ORIGINATION FORM

Proposed Revisions to a Standard Plans Index
(Please provide all information — Incomplete forms will be returned)

Index Number: 646-001
Sheet Number (s): 1 of 1
Index Title:
Aluminum Post and Pedestal Mounted
Pedestrian Detectors and Signals

PEDESTAL MOUNTED

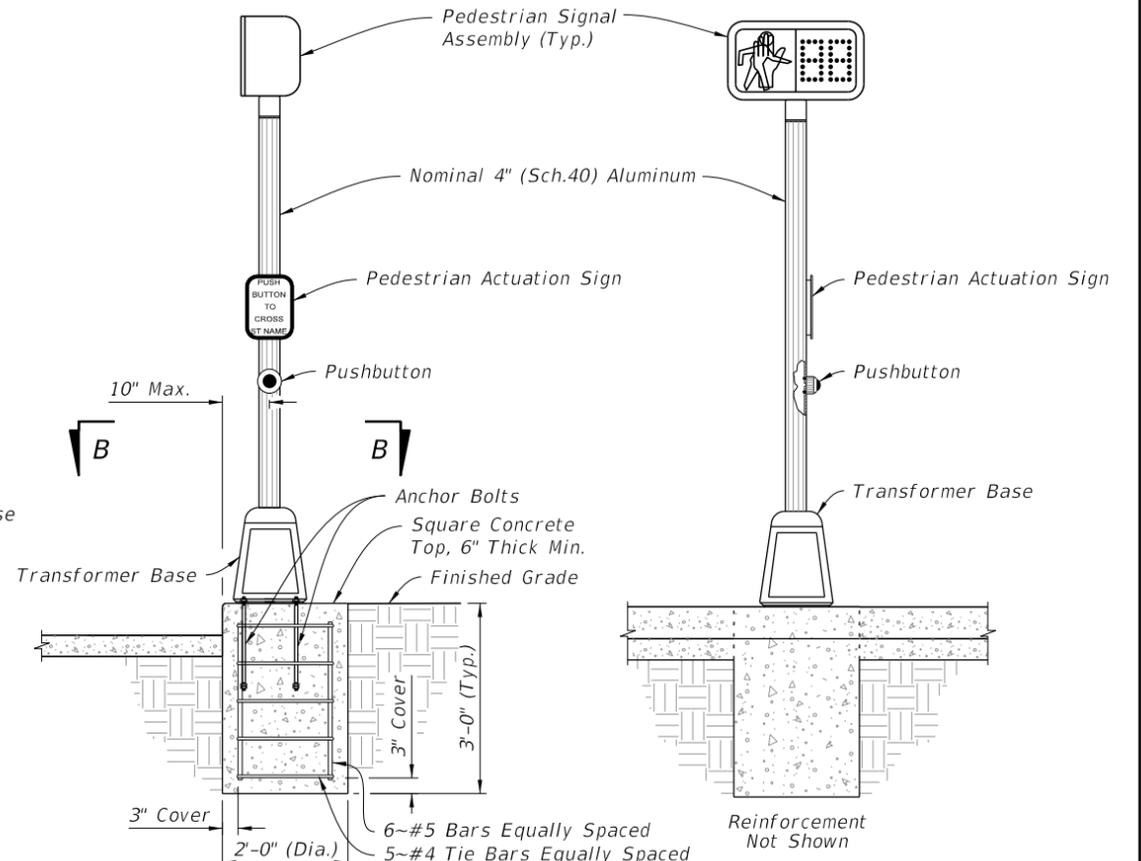
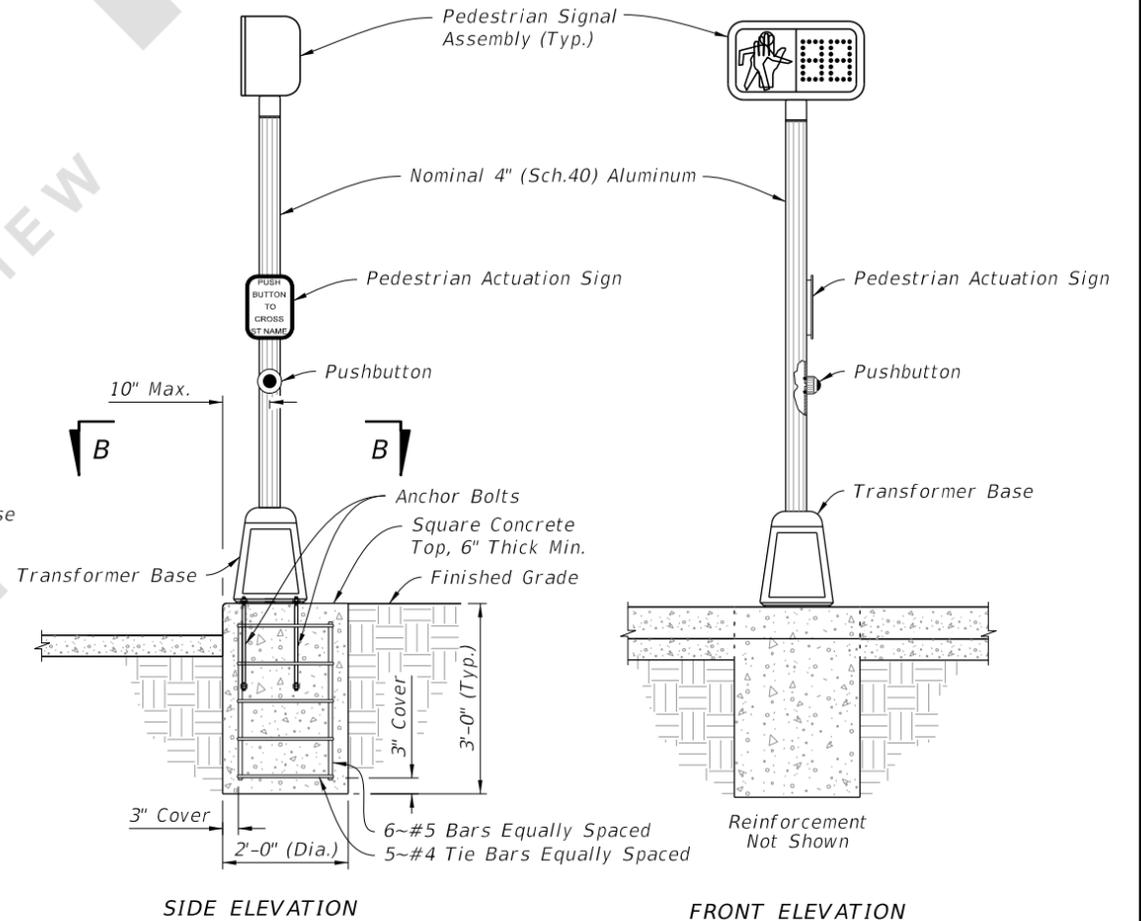
Updated the PEDESTAL MOUNTED detail - to show in the ADJACENT TO SIDEWALK detail "Tie Bars" callout as a #4 Stirrups equally spaced, with a 12" maximum spacing; Changed NOTE 4 from "Class I" to "Class II".

CHANGED TO: #4 Stirrups Equally Spaced, 12" Max.
